## DESCRIPTIVE REPORT

*Registry No.* ..... **H-11182**

*Sublocality* ..... **Valdez Narrows**

# Descriptive Report to Accompany Hydrographic Survey H11182

Figure 2. H11182 Junction Surveys.

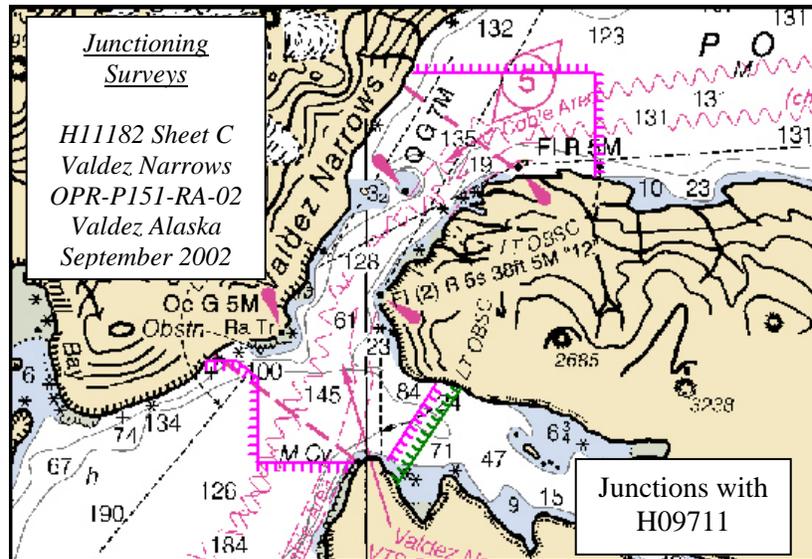
Survey H09711 junctions well with this survey. A cursory comparison indicates differences are generally less than a fathom with the exception of greater differences of up to 10 fathoms along the steep slopes.

Final comparisons will be made after the application of smooth tides.<sup>6</sup>

- <sup>6</sup> Concur with clarification. H-9711 is not a contemporary survey. No junction comparison with H-9711 was completed at PHB. A comparison with H11181 (1:10,000, 2002, NE) results in good agreement within the junction.
